CITY OF ROOSEVELT PARK PLANNING COMMISSION MEETING January 30, 2023

The applicant, Restaurant Holdings LLC, has submitted for Special Use Approval to demolish the existing office building at 3145 Henry Street, and replace it with a Taco John's fast food restaurant, including a drive-thru, and a second, smaller building that would also have a drive-through. McKenna has been asked by the City Manager to review the proposal against the City's Master Plan and Zoning Ordinance and provide a recommendation to the Planning Commission.

**Subject: Taco John's, 3145 Henry Street
Preliminary Site Plan Review**

SHEET NO.
C2.0

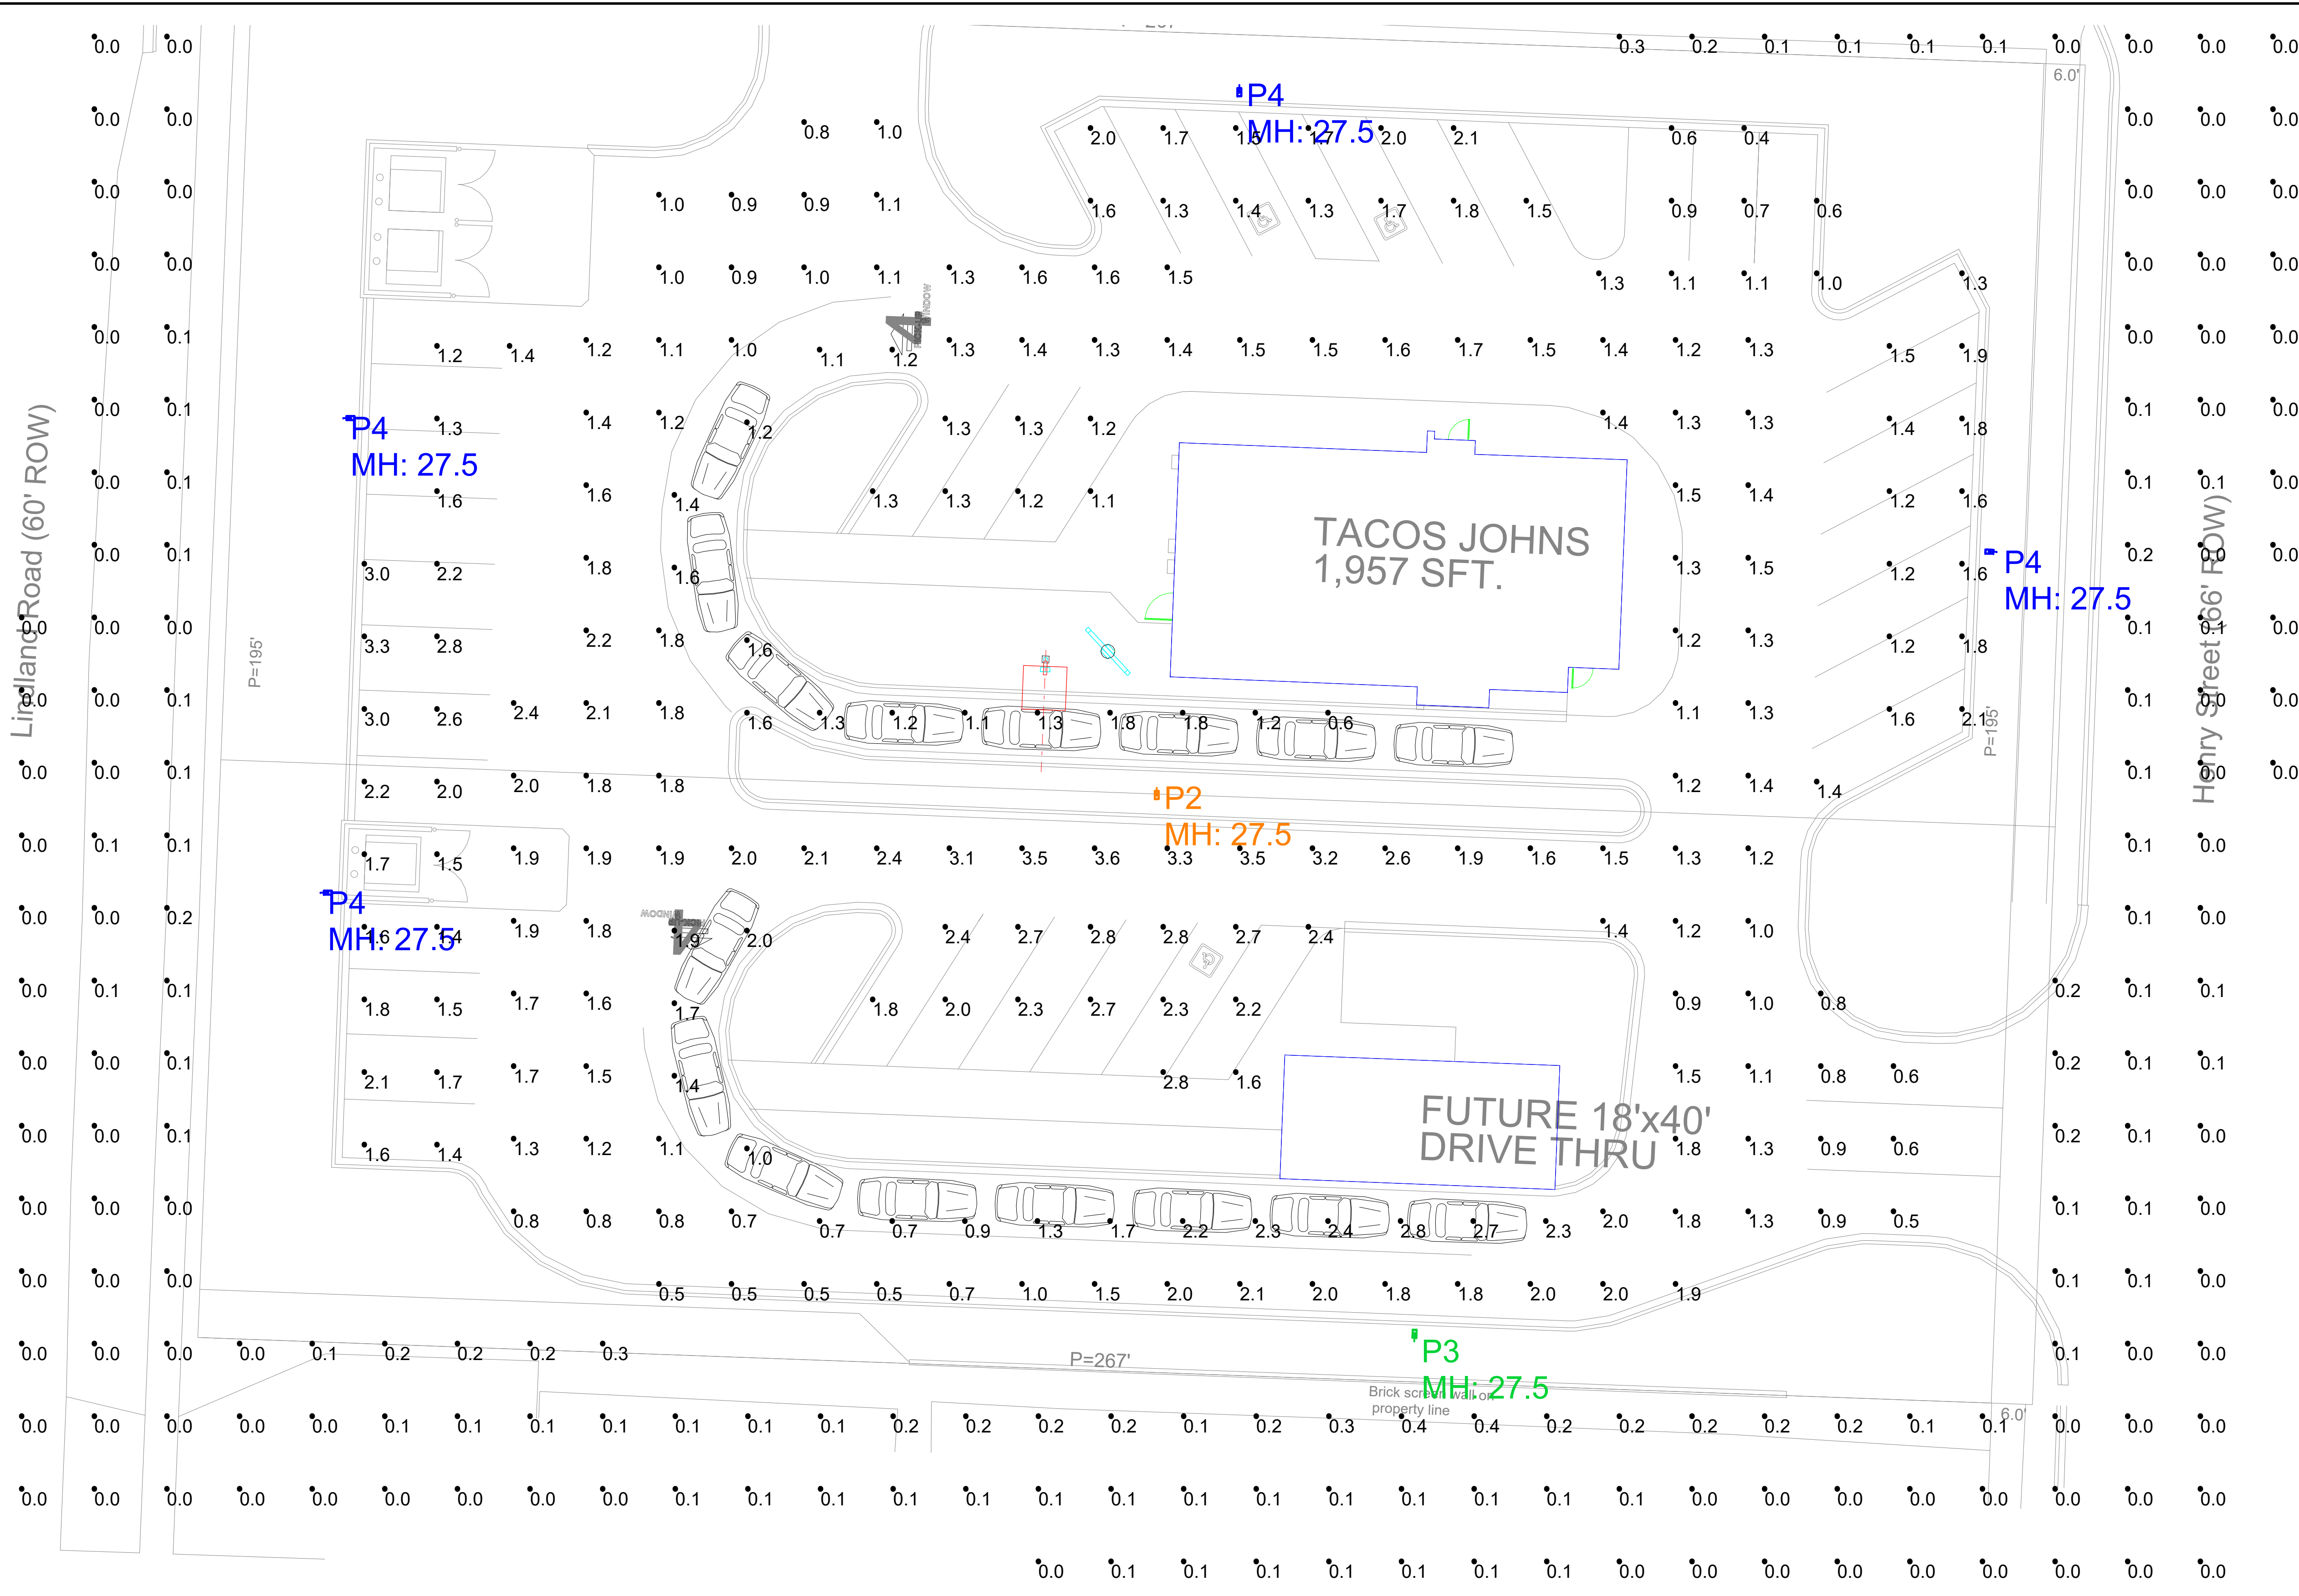
- a. Lot Split:** A lot split is proposed so that the Taco John's and the other business will be on separate lots. Because the two lots will share a parking lot, a cross access agreement must be submitted for City approval. Submission of the signed agreement will be a condition of Site Plan Approval. The dimensional requirements for lots in the C-E District are as follows:
- **Minimum Width:** 50 feet. The exact widths of the two lots are not included on the plan. However, the Taco John's lot will be at least 74 feet wide, and the other lot will be at least 53 feet wide, based on other dimensions included on the plan.
 - **Minimum Area:** There is no minimum lot area in the C-E District, provided that the minimum width is met.

- c. **Rear Setback:** The required rear yard setback is 25 feet. It is met for both buildings on both lots.
- d. **Side Setback:** The required side setbacks are 6 feet. All side setbacks are in compliance.
- e. **Building Height.** The maximum building height is 35 feet. While the plan notes that both buildings will be one story, the actual height in feet must be submitted.
- f. **Lot Coverage.** The maximum lot coverage is 35%. Both parcels appear to comply, but the plan must include the actual lot coverage percentage for both lots.

- a. **Number of Parking Spaces.** The parking standard for restaurants with drive-throughs is one space per 100 square feet of floor area. The Taco John's building is proposed to be 1,957 square feet (for 20 required spaces) and the other building is proposed to be 720 square feet (for 8 required spaces). 27 spaces are provided on the Taco John's lot, and 9 are provided on the other lot, so the plan is in compliance.
- b. **Parking and Access Dimensions.** Most parking spaces and access aisles meet or exceed City dimensional standards, except the parking spaces at the west end of the site, which are only 19 feet deep. 20 feet is required.

- c. **Barrier-Free Parking.** Two barrier-free spaces are required on the Taco John's lot (note: this could be reduced to one if the number of total parking spaces is reduced to 25 or fewer in subsequent revisions). One barrier-free space is required on the other lot. The required barrier-free spaces are included on the plans.
- d. **Loading Docks.** There are less than 2,000 square feet of building space on both lots, so neither lot requires a loading space.

- g. **Drive-Through Requirements.** Section 10.6.W.1 requires room for at least 8 stacking spaces without blocking drive aisles or public roads. This requirement is met on both lots. Section 10.6.W.2 requires two parking spaces “in close proximity” to the exist of the drive-through, for people to pull to when their order is not ready at the window. The Taco John’s lot meets this requirement, but the other lot does not.
3. **Signage.** In our site plan letter, we recommended a condition of Site Plan Approval that all menu boards with audio or video capabilities be set back at least 100 feet from Lindland Road. On the current plan, the signs meet that requirement.

- **Henry Street:** A landscaped area 20 feet wide, with a “solid screen comprised of a hedge or decorative wall” OR canopy trees space every 3- feet (3 trees on the Taco John’s site and two trees on the other site). There are two large trees in the front yard of the existing building. The preliminary site plan shows one of them being preserved on the non-Taco John’s site, but does not show any other trees, nor a decorative wall or shrub screen.

- **Cranbrook Road (from the proposed driveway east):** A landscaped area 20 feet wide, with a “solid screen comprised of a hedge or decorative wall” OR canopy trees space every 30 feet (approximately four trees, though the distance should be dimensioned on the plans to confirm). The preliminary site plan does not show any trees, nor a decorative wall or shrub screen.

- **Cranbrook Road (from the proposed driveway west):** A landscaped area 20 feet wide, with canopy trees space every 20 feet (approximately four trees, though the distance should be dimensioned on the plans to confirm) AND a six foot high continuous screen made of plant material, berming, screen wall, or fence. If a wall or fence is used, then both sides of the fence must be lined with four shrubs per 20 feet, unless the fence/wall is located on the property line, in which landscaping is only required on the interior side of the fence or wall. The preliminary site plan shows three existing trees, plus one in the Cranbrook Road right-of-way, which, if left in place, meet the tree requirement. Using the Planning Commission’s authority to alter buffer requirements (See Section 11.2.F.7), we recommend that six foot tall evergreens be planted to form a continuous screen between the existing trees and the driveway, but that no other landscaping, fence, or wall be required in the vicinity of the existing trees. This would meet the spirit of the Ordinance, while keeping the existing “lawn” feeling. It would also be less likely to threaten the long-term viability of the existing trees than building a fence in their immediate vicinity.

- **Lindland Road:** A landscaped area 20 feet wide, with canopy trees space every 20 feet (10 trees) AND a six foot high continuous screen made of plant material, berming, screen wall, or fence. If a wall or fence is used, then both sides of the fence must be lined with four shrubs per 20 feet, unless the fence/wall is located on the property line, in which landscaping is only required on the interior side of the fence or wall. The preliminary site plan shows 10 existing trees, plus two more in the Lindland right-of-way, which, if left in place, meet the tree requirement. For the screening requirement, we recommend that six foot tall evergreens be planted to fill the gaps between the existing trees. While this would not necessarily be “continuous”, it would meet the spirit of the Ordinance, while keeping the existing “lawn” feeling. It would also be less likely to threaten the long-term viability of the existing trees than building a fence in their immediate vicinity.

- b. Buffer Landscaping.** Adjacent to the house southwest of the site, a landscaped area 20 feet wide, with canopy trees space every 20 feet (approximately 6 trees, though the distance should be dimensioned on the plans to confirm) AND a six foot high continuous screen made of plant material, berming, screen wall, or fence. If a wall or fence is used, then both sides of the fence must be lined with four shrubs per 20 feet, unless the fence/wall is located on the property line, in which landscaping is only required on the interior side of the fence or wall. The preliminary site plan shows 9 existing trees, which, if left in place, meet the tree requirement. There is also a fence on the plans, which meets the fence requirement. However the buffer zone is not 20 feet wide, and does not have the required shrubs.

- **One island per 12 parking spaces:** Landscape requirements are generally rounded up, for a requirement of three islands. Two landscape islands have been provided, and no landscaping is shown on them on the preliminary plan, and one of the islands will be largely incorporated into the frontage landscaping once it is widened to 20 feet. The applicant may wish to consider reducing the number of parking spaces to 24, which would eliminate one required island while still complying with the minimum parking requirement.

- **Minimum Island Size: 90 square feet.** This appears to be met for both landscape islands, though the exact area should be submitted to be sure.
- d. Pedestrian Walkway Landscaping:** Section 11.6.G.1.b requires at least 50% of the length of pedestrian walkways from the sidewalk to building entrances to be lined with "landscaping, benches, and bicycle facilities." This standard can be met on the non-Taco-John's site, where most of the walkway passes through landscape areas or areas where benches or bike racks could be located. However, the way the preliminary plan is designed, the walkway on the Taco John's site will not be able to meet this requirement.

- e. Dumpster Landscaping:** Section 11.3.E requires a continuous opaque screen (berming, plant material, screen walls or fences) to surround all dumpsters. Dumpster enclosures are shown on the plan, but the height and material of the enclosures must be submitted. The applicant may also wish to consider having a single dumpster enclosure for both restaurants, which would be permitted provided that there is an agreement in place to allow both buildings to use the dumpster enclosure in perpetuity. Such an agreement would have to be submitted to the City for approval as a condition of Site Plan Approval.

The concerns listed in this letter must be addressed on a revised Site Plan prior to approval by the Planning Commission.

PHOTOMETRIC PLAN

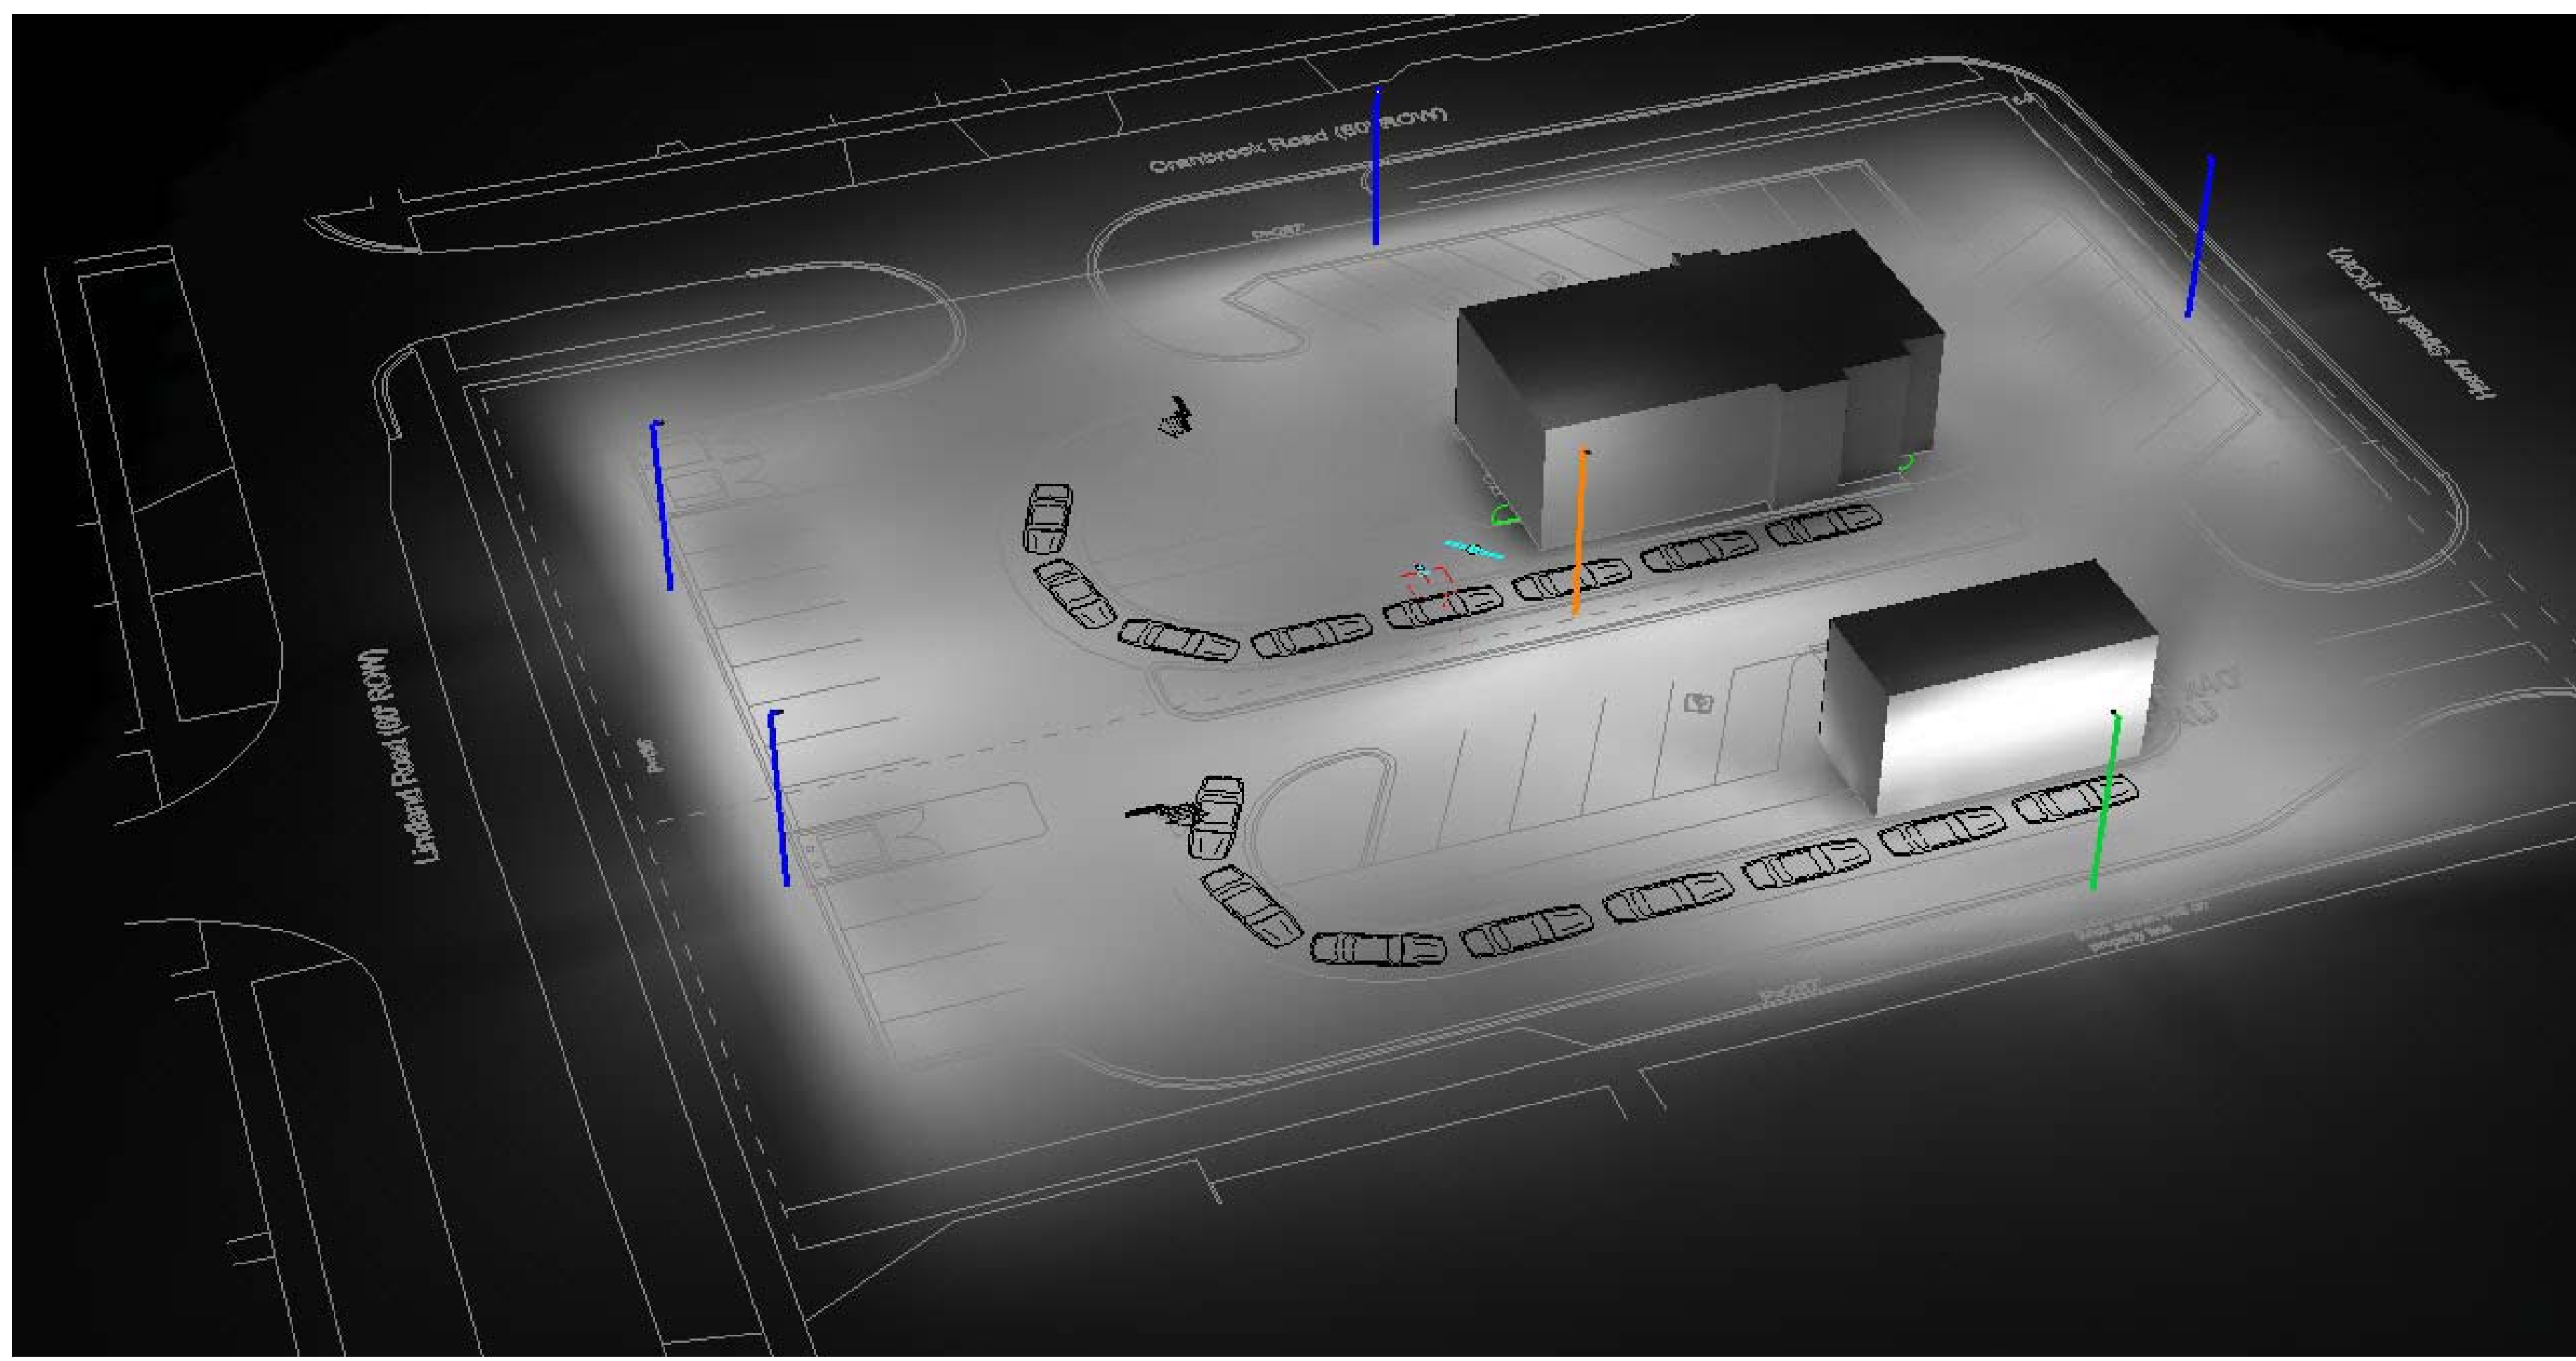
- Although there is no explicit requirement in Section 3.17 that light emanating from a property reach 0 footcandles at the property line, we recommend that that standard be applied to all portions of the property that abut residential or are across the street from residential, as a condition of approval. According to the photometric plan submitted by the applicant, the design is very close to hitting 0.0 footcandles along Lindland (some areas are 0.1), but the portion of Cranbrook where the house is across the street is not included. The lot line abutting the home to the southwest is at 0.2/0.3 footcandles and must be reduced. See our Site Plan letter.

- a. **Lighting provided for security or visibility on any site shall be shielded to reduce glare and shall be so arranged and maintained as to direct the light away from any Residential District or use.** Cut sheets of the proposed light fixtures must be submitted to confirm that this requirement is met. Additionally, in our Special Use review, we recommended a more objective standard to achieve this goal – 0.0 footcandles of light along Cranbrook Road, Lindland Road, and the southwest property line. According to the photometric plan submitted by the applicant, the design is very close to hitting 0.0 footcandles along Lindland (some areas are 0.1), but the portion of Cranbrook where the house is across the street is not included. The lot line abutting the home to the southwest is at 0.2/0.3 footcandles and must be reduced.
